Commonwealth Edison Company  
Quad Cities Generating Station  
22710 206th Avenue North  
Cordova, IL 61242-9740  
Tel 309-654-2241

ESK-96-049

Subject: Quad Cities Nuclear Power Station Unit 1  
Submittal of Weld Overlay Repair Designs and Flawed Pipe Evaluations  
NRC Docket No. 50-254

# ENGINEERING CHANGE NOTICE

ECN No. 04-01333M

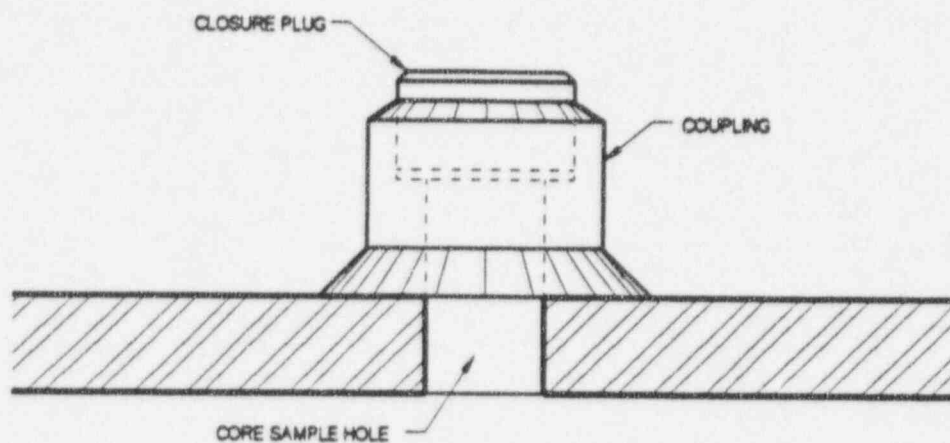
4.2.1	This Section describes requirements for the removal of existing plug connections (reference Typical Plug Connection Detail, this ECN page 8) originally installed to cover core samples removed from weldment 02BS-S12 in the mid-1980's. These plug connections will be removed and replaced with backing plugs (reference Backing Plug Installation Detail, this ECN page 8) which in turn will be covered by the weld overlay repair described in Sketch 1598-00044.010-0207 (this ECN page 9).
4.2.2	The work sequence shall be controlled through the use of a process control traveller detailing the steps required to perform this work. As a minimum, the following activity sequences shall be described:
4.2.2.1	Identification: Identify candidate weldment, identify core sample branch connection(s), remove interferences, etc.

**TYPICAL PLUG CONNECTION DETAIL**  
(TYPICAL 2 PLACES)

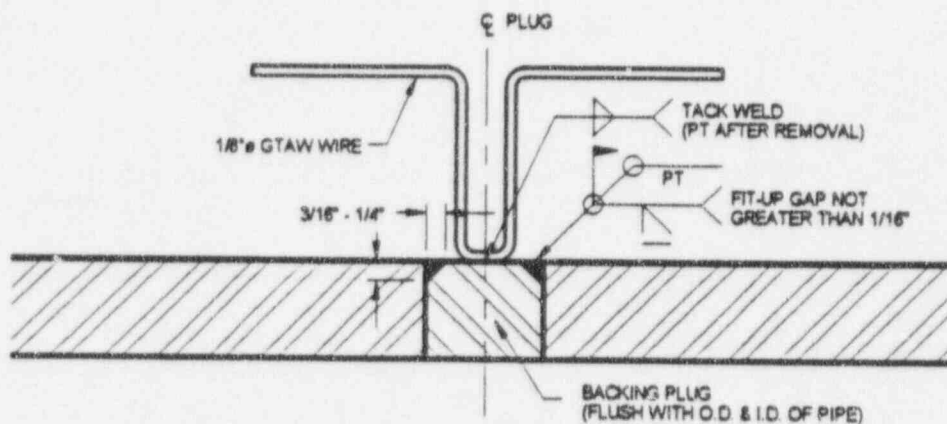
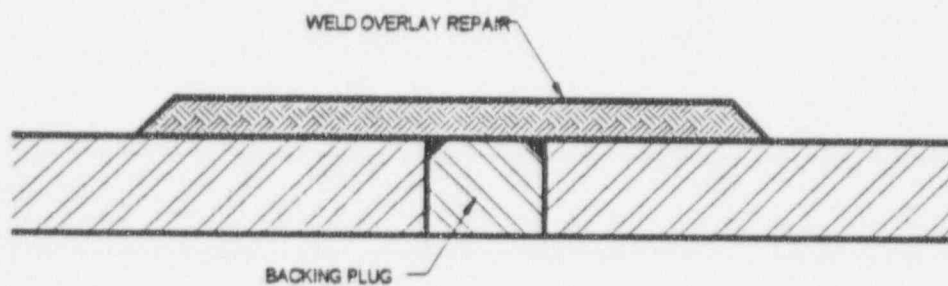
- 4.2.2.2 Removal: Verify that the run pipe is drained of water, remove plug connection by grinding/saw cutting such that run pipe wall thickness is not reduced, avoid the introduction of any material into the run pipe, use plant-approved tape to cover opening until backing plug welding is begun, etc.

- 4.2.2.4 Welding: Identify appropriate welding procedure and qualified welder, obtain filler material, clean/prepare run pipe and backing plug (avoiding the introduction of any material into the run pipe), fit-up and tack weld backing plug, remove temporary handling device, seal weld backing plug, grind/flap finished seal weld and any remnants of temporary handling device flush with run pipe surface, perform PT and VT examination of welded areas, etc.

- 4.2.2.5 Overlay Application: Verify that backing plug installation and inspection are complete and that the run pipe is reflooded with water, perform weld overlay repair as described in this ECN.

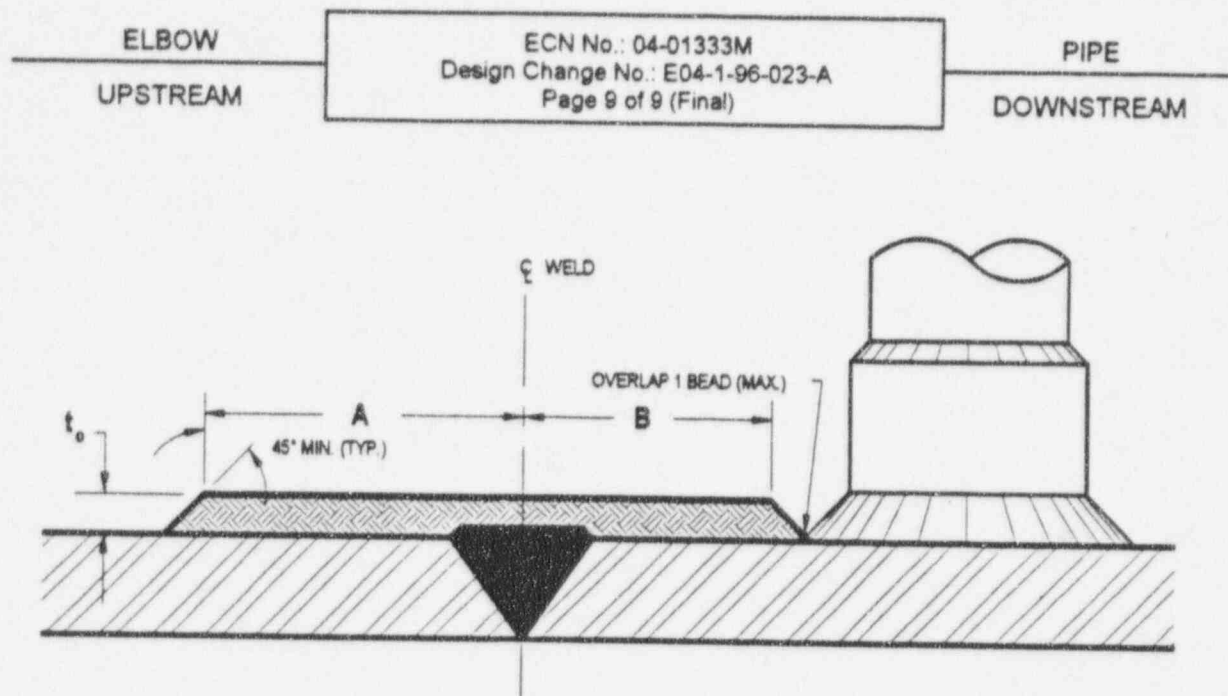
WELD NUMBER		FLAW CHARACTERIZATION		DESIGN DIMENSIONS			COMMENTS
				t <sub>o</sub>	A	B	
02BS-S12		100% thru wall by 360° length		0.41"	4.5"	(3)	NUREG-0313, Rev. 2 "Standard" Overlay Design
0	<i>2/1/96</i>	<i>KM 3/21/96</i>	<i>EPL 3/21/96</i>	<i>SW 3/21/96</i>	<i>3/21/96</i>		Issued for Construction.
REV.	PREP. BY/ DATE	CHK. BY/ DATE	P.E. APPR./ DATE	E.M. APPR./ DATE	P.M. APPR./ DATE	DESCRIPTION	
JOB NO.: 1598-00044.010			PLANT/UNIT: Quad Cities Unit 1			 VECTRA	SHT. 1 OF 1  REV. 0
FILE NO.: XCE042.0207			SKETCH NO.: 1598-00044.010-0207

4.1.3	Detailed joint configuration information and thickness data shall be reported to Engineering <u>prior</u> to application of the overlay.
4.1.4	During weld overlay implementation, the "as-built" configuration shall be recorded on a Weld Overlay Data Sheet as specified in Document No. COE-107-500, Latest Revision.

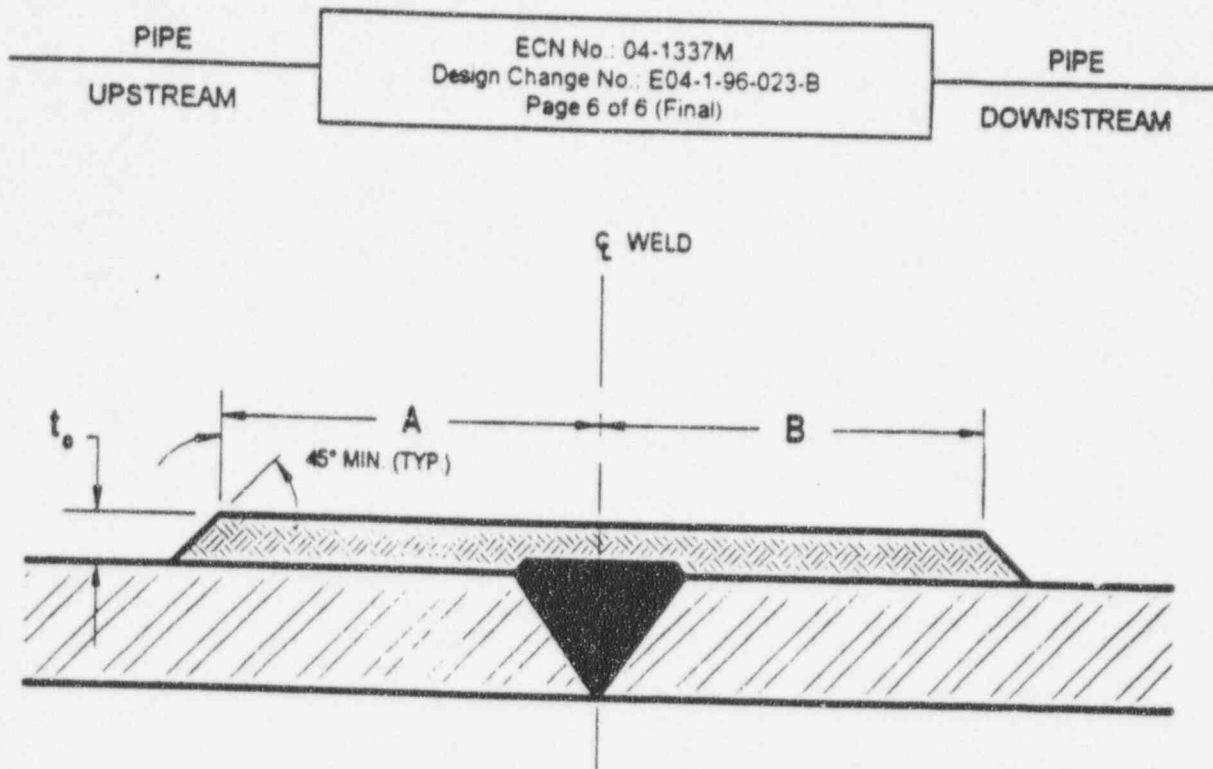
WELD NUMBER	FLAW CHARACTERIZATION	DESIGN DIMENSIONS			COMMENTS		
		$t_o$	A	B			
02AS-S5	100% thru wall by 360° length	0.45"	4.5"	4.5"	NUREG-0313, Rev. 2 "Standard" Overlay Design		
0	TEO 3/22/96	JSM 3/22/96	RPC 3/22/96	3/23/96	Issued for Construction.		
REV.	PREP. BY/ DATE	CHK. BY/ DATE	P.E. APPR./ DATE	E.M. APPR./ DATE	P.M. APPR./ DATE	DESCRIPTION	
JOB NO.: 1598-00044.010		PLANT/UNIT: Quad Cities Unit 1		 <b>VECTRA</b>		SHT. 1 OF 1	REV. 0
FILE NO.: XCE042.0208		SKETCH NO.: 1598-00044.010-0208

4.1.2	Detailed joint configuration information and thickness data shall be reported to Engineering <u>prior</u> to application of the overlay.
4.1.3	During weld overlay implementation, the "as-built" configuration shall be recorded on a Weld Overlay Data Sheet as specified in Document No. COE-107-500, Latest Revision.

4.1.4	The base materials to which this WOR is to be applied contain low levels of delta ferrite (<5 FN). In an effort to compensate for the dilution effect this low ferrite material will have on deposited weld metal, it is recommended that the weld filler material used for the first layer be selected on the basis of its ability to produce a deposit meeting the requirements of Document No. COE-107-500 (minimum 7.5 FN as-deposited). For the first layer, it may therefore be necessary to use filler material capable of producing an undiluted weld deposit double the minimum acceptable delta ferrite specified in COE-107-500.

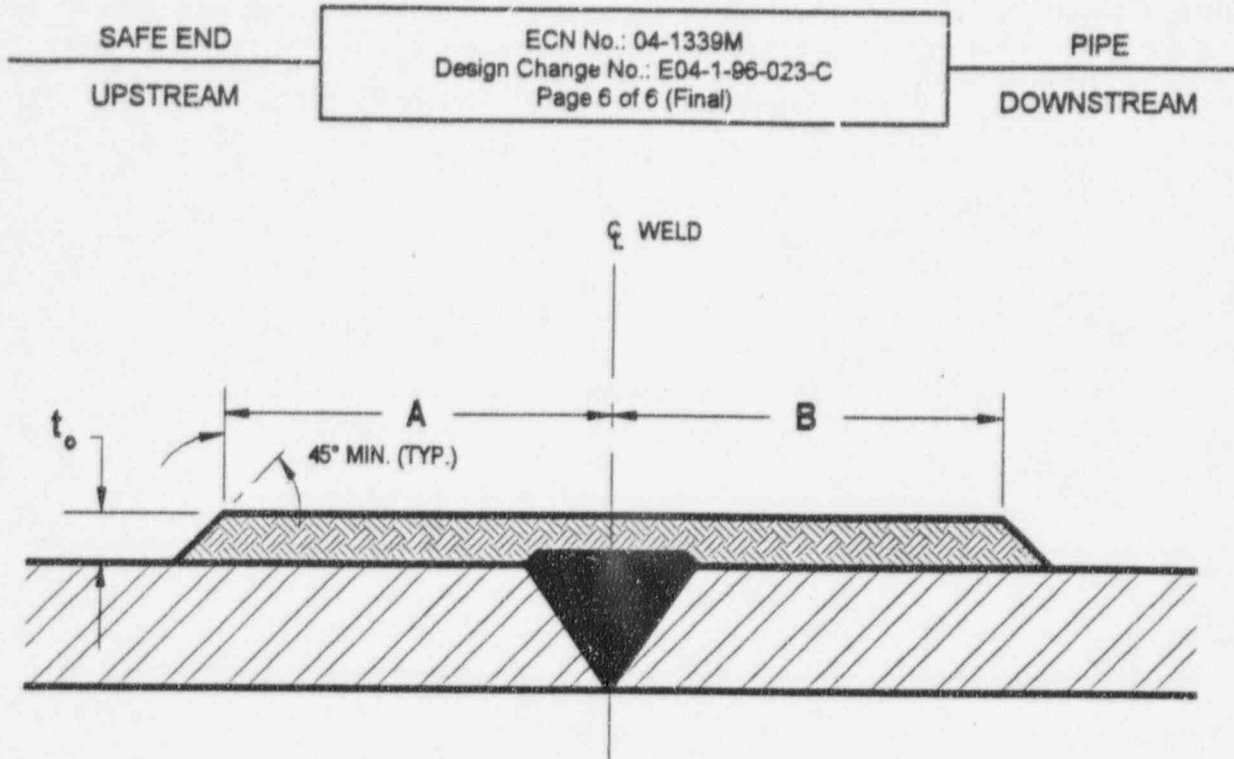
WELD NUMBER	FLAW CHARACTERIZATION	DESIGN DIMENSIONS			COMMENTS		
		$t_o$	A	B			
02AS-F2	100% thru wall by 360° length	0.45"	4.5"	4.5"	NUREG-0313, Rev. 2 "Standard" Overlay Design		
0	<i>3/25/96</i> <i>TSM</i> <i>3/25/96</i> <i>RPC</i> <i>3/25/96</i> <i>CRJ</i> <i>3/25/96</i> <i>BW</i> <i>3/26/96</i>				Issued for Construction.		
REV.	PREP. BY/ DATE	CHK. BY/ DATE	P.E. APPR./ DATE	E.M. APPR./ DATE	P.M. APPR./ DATE	DESCRIPTION	
JOB NO.: 1598-00044.010		PLANT/UNIT: Quad Cities Unit 1		 <b>VECTRA</b>		SHT. 1 OF 1	REV. 0
FILE NO.: XCE042.0209		SKETCH NO.: 1598-00044.010-0209

4.1.2	Detailed joint configuration information and thickness data shall be reported to Engineering <u>prior</u> to application of the overlay.
4.1.3	During weld overlay implementation, the "as-built" configuration shall be recorded on a Weld Overlay Data Sheet as specified in Document No. COE-107-500, Latest Revision.

4.1.4	The base materials to which this WOR is to be applied contain low levels of delta ferrite (<5 FN). In an effort to compensate for the dilution effect this low ferrite material will have on deposited weld metal, it is recommended that the weld filler material used for the first layer be selected on the basis of its ability to produce a deposit meeting the requirements of Document No. COE-107-500 (minimum 7.5 FN as-deposited). For the first layer, it may therefore be necessary to use filler material capable of producing an undiluted weld deposit double the minimum acceptable delta ferrite specified in COE-107-500.

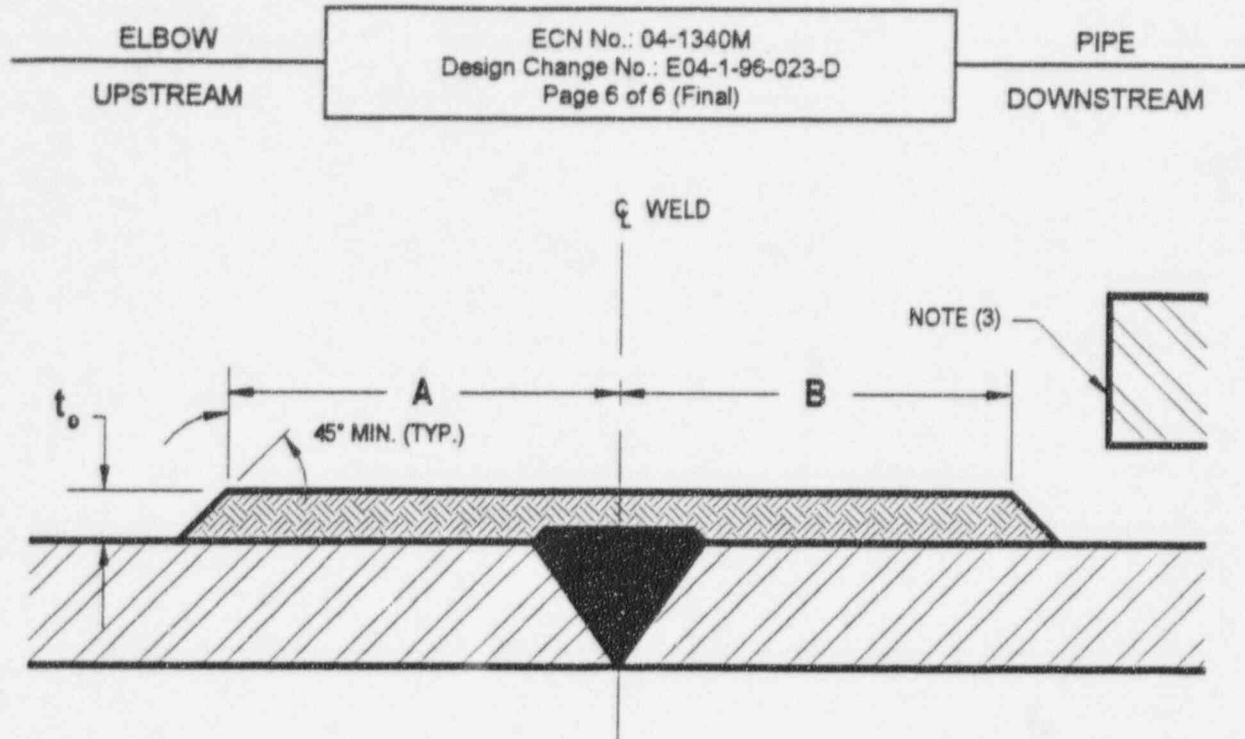
WELD NUMBER		FLAW CHARACTERIZATION		DESIGN DIMENSIONS			COMMENTS
				t <sub>b</sub>	A	B	
02AS-S4		100% thru wall by 360° length		0.45"	4.5"	(3)	NUREG-0313, Rev. 2 "Standard" Overlay Design
0	<del>Rev</del> 3/25/96	KM 3/25/96	RAC 3/25/96	CH 3/25/96	<del>Rev</del> 3/26/96	Issued for Construction.	
REV.	PREP. BY/ DATE	CHK. BY/ DATE	P.E. APPR./ DATE	E.M. APPR./ DATE	P.M. APPR./ DATE	DESCRIPTION	
JOB NO.: 1598-00044.010			PLANT/UNIT: Quad Cities Unit 1			 VECTRA	REV.
FILE NO.: XCE042.0210			SKETCH NO.: 1598-00044.010-0210				SHT. 1 OF 1 0

4.1.2	Detailed joint configuration information and thickness data shall be reported to Engineering <u>prior</u> to application of the overlay.
4.1.3	During weld overlay implementation, the "as-built" configuration shall be recorded on a Weld Overlay Data Sheet as specified in Document No. COE-107-500, Latest Revision.

4.1.4	The base materials to which this WOR is to be applied contain low levels of delta ferrite (< 5 FN). In an effort to compensate for the dilution effect this low ferrite material will have on deposited weld metal, it is recommended that the weld filler material used for the first layer be selected on the basis of its ability to produce a deposit meeting the requirements of Document No. COE-107-500 (minimum 7.5 FN as-deposited). For the first layer, it may therefore be necessary to use filler material capable of producing an undiluted weld deposit double the minimum acceptable delta ferrite specified in COE-107-500.

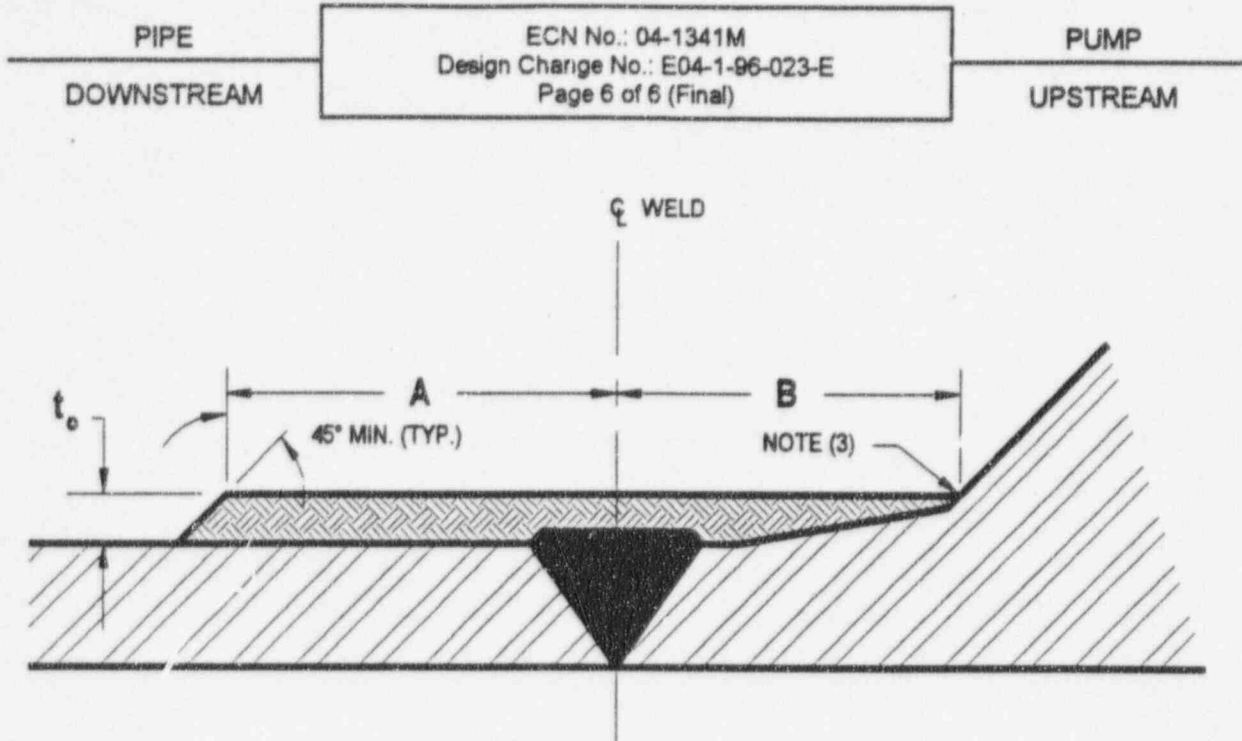
WELD NUMBER		FLAW CHARACTERIZATION		DESIGN DIMENSIONS			COMMENTS
				t <sub>o</sub>	A	B	
02AD-F12		100% thru wall by 360° length		0.49"	4.5"	(3)	NUREG-0313, Rev. 2 "Standard" Overlay Design
0	<i>3/25/96</i>	<i>71m 3/25/96</i>	<i>RPC 3/25/96</i>	<i>CHT 3/25/96</i>	<i>18B 3/26/96</i>	Issued for Construction.	
REV.	PREP. BY/ DATE	CHK. BY/ DATE	P.E. APPR./ DATE	E.M. APPR./ DATE	P.M. APPR./ DATE	DESCRIPTION	
JOB NO.:			PLANT/UNIT:		 VECTRA	SHT. 1  OF 1	REV.  0
1598-00044.010			Quad Cities Unit 1				
FILE NO.:			SKETCH NO.:				
XCE042.0211			1598-00044.010-0211

4.1.2	Detailed joint configuration information and thickness data shall be reported to Engineering <u>prior</u> to application of the overlay.
4.1.3	During weld overlay implementation, the "as-built" configuration shall be recorded on a Weld Overlay Data Sheet as specified in Document No. COE-107-500, Latest Revision.

4.1.4	The base materials to which this WOR is to be applied contain low levels of delta ferrite (<5 FN). In an effort to compensate for the dilution effect this low ferrite material will have on deposited weld metal, it is recommended that the weld filler material used for the first layer be selected on the basis of its ability to produce a deposit meeting the requirements of Document No. COE-107-500 (minimum 7.5 FN as-deposited). For the first layer, it may therefore be necessary to use filler material capable of producing an undiluted weld deposit double the minimum acceptable delta ferrite specified in COE-107-500.

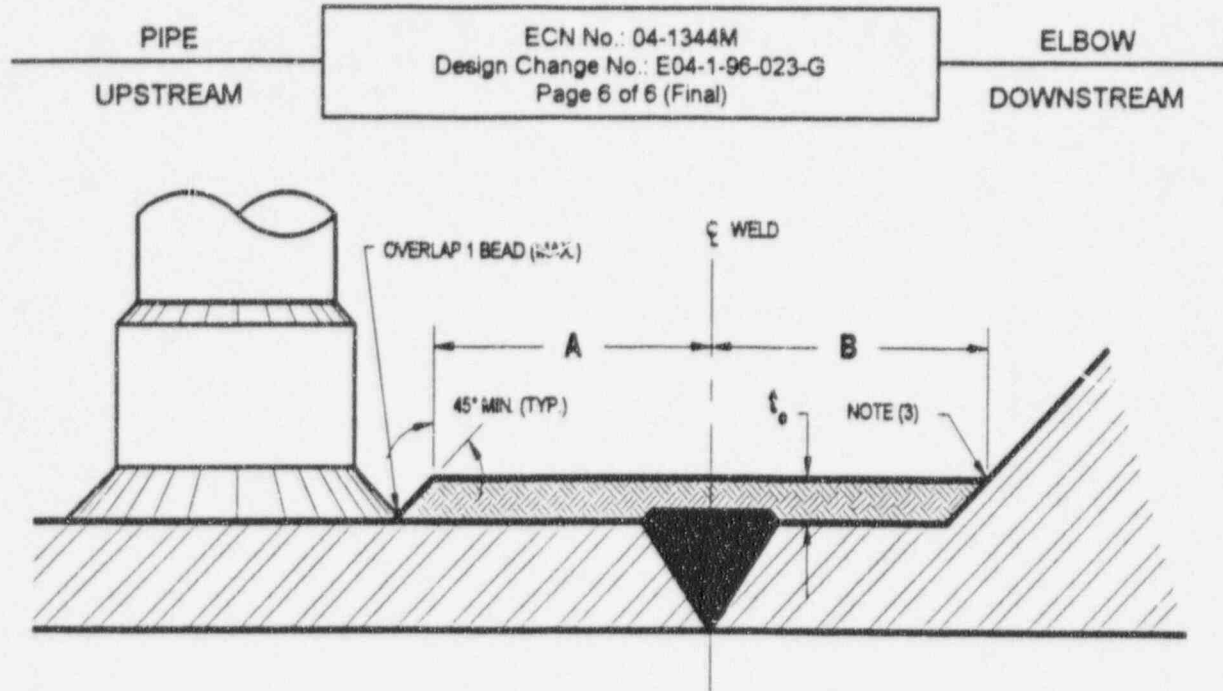
WELD NUMBER		FLAW CHARACTERIZATION		DESIGN DIMENSIONS			COMMENTS	
				$t_o$	A	B		
02AS-F14		100% thru wall by 360° length		0.48"	(3)	(3)	NUREG-0313, Rev. 2 "Standard" Overlay Design	
0	<i>3/29/96</i>	<i>3/29/96</i>	<i>3/29/96</i>	<i>3/29/96</i>	<i>3/29/96</i>	<i>3/29/96</i>	Issued for Construction.	
REV.	PREP. BY/ DATE	CHK. BY/ DATE	P.E. APPR./ DATE	E.M. APPR./ DATE	P.M. APPR./ DATE	DESCRIPTION		
JOB NO.: 1598-00044.010			PLANT/UNIT: Quad Cities Unit 1		 <b>VECTRA</b>		SHT. 1 OF 1	REV.  0
FILE NO.: XCE042.0214			SKETCH NO.: 1598-00044.010-0214

4.1.2	Detailed joint configuration information and thickness data shall be reported to Engineering <u>prior</u> to application of the overlay.
4.1.3	During weld overlay implementation, the "as-built" configuration shall be recorded on a Weld Overlay Data Sheet as specified in Document No. COE-107-500, Latest Revision.

4.1.4	The base materials to which this WOR is to be applied contain low levels of delta ferrite (<5 FN). In an effort to compensate for the dilution effect this low ferrite material will have on deposited weld metal, it is recommended that the weld filler material used for the first layer be selected on the basis of its ability to produce a deposit meeting the requirements of Document No. COE-107-500 (minimum 7.5 FN as-deposited). For the first layer, it may therefore be necessary to use filler material capable of producing an undiluted weld deposit double the minimum acceptable delta ferrite specified in COE-107-500.

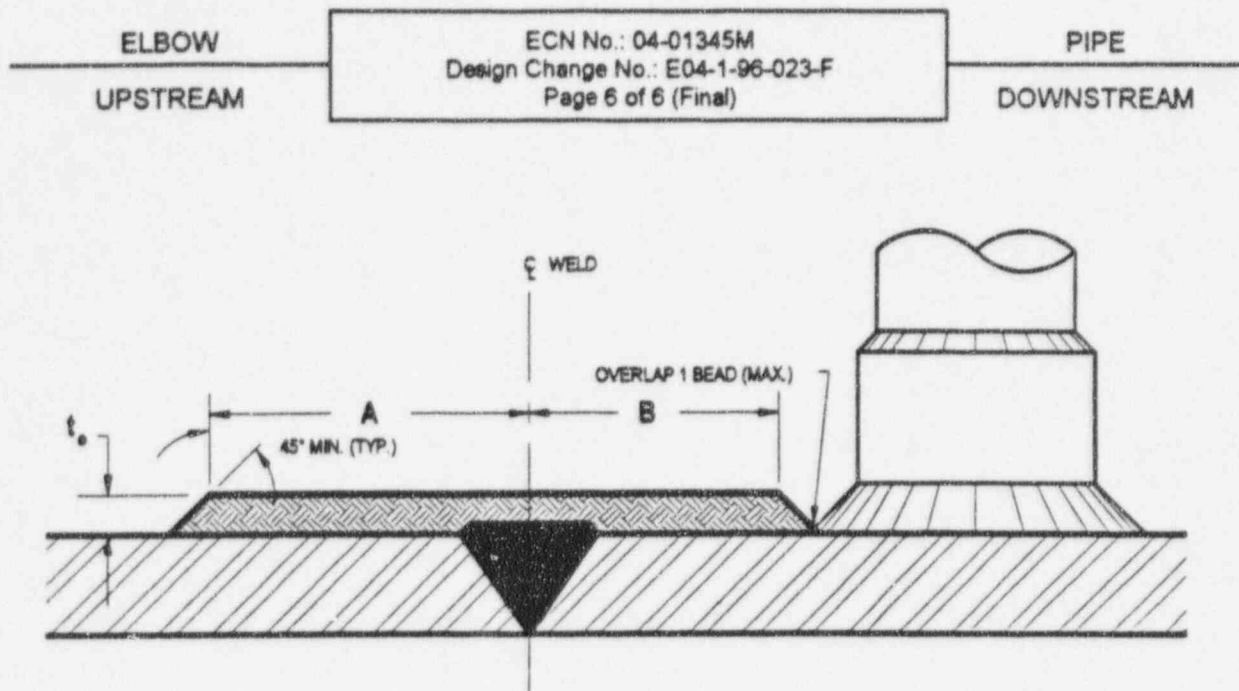
WELD NUMBER		FLAW CHARACTERIZATION		DESIGN DIMENSIONS			COMMENTS
				t <sub>o</sub>	A	B	
02AS-S12		100% thru wall by 360° length		0.50"	4.5"	(3)	NUREG-0313, Rev. 2 "Standard" Overlay Design
0	<i>3/29/96</i>	<i>7/17/96</i>	<i>RPC 3/29/96</i>	<i>CW 3/29/96</i>	<i>3/29/96</i>	Issued for Construction.	
REV.	PREP. BY/ DATE	CHK. BY/ DATE	P.E. APPR./ DATE	E.M. APPR./ DATE	P.M. APPR./ DATE	DESCRIPTION	
JOB NO.: 1598-00044.010			PLANT/UNIT: Quad Cities Unit 1		 VECTRA		REV.  0
FILE NO.: XCE042.0213			SKETCH NO.: 1598-00044.010-0213				SHT. 1 OF 1

4.1.2	Detailed joint configuration information and thickness data shall be reported to Engineering <u>prior</u> to application of the overlay.
4.1.3	During weld overlay implementation, the "as-built" configuration shall be recorded on a Weld Overlay Data Sheet as specified in Document No. COE-107-500, Latest Revision.

4.1.4	The base materials to which this WOR is to be applied contain low levels of delta ferrite ( $< 5$ FN). In an effort to compensate for the dilution effect this low ferrite material will have on deposited weld metal, it is recommended that the weld filler material used for the first layer be selected on the basis of its ability to produce a deposit meeting the requirements of Document No. COE-107-500 (minimum 7.5 FN as-deposited). For the first layer, it may therefore be necessary to use filler material capable of producing an undiluted weld deposit double the minimum acceptable delta ferrite specified in COE-107-500.
